Technical Bulletin

N°: TECB-08-12-15_RO

Diamond model considered :FSM-2V6E/N

Problem :Differential of temperature too important.

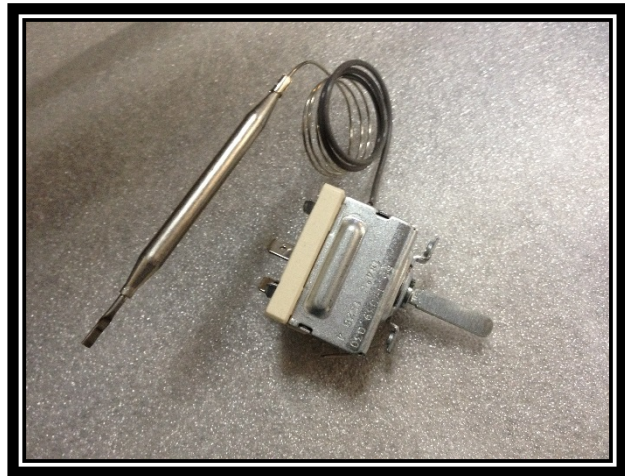
Action (what-when) :The differential you find during testing could be normal during cooking, it is depend on the loading of food. The power of fryer should compensate this phenomena. But to reduce that we decide to change the actual thermostat with another one from EGO.

Technical solution suggested :Thermostat replacement.

New replacing spare parts codes : No part code change to avoid any confusion

Actual model : A06056

New model: A06056
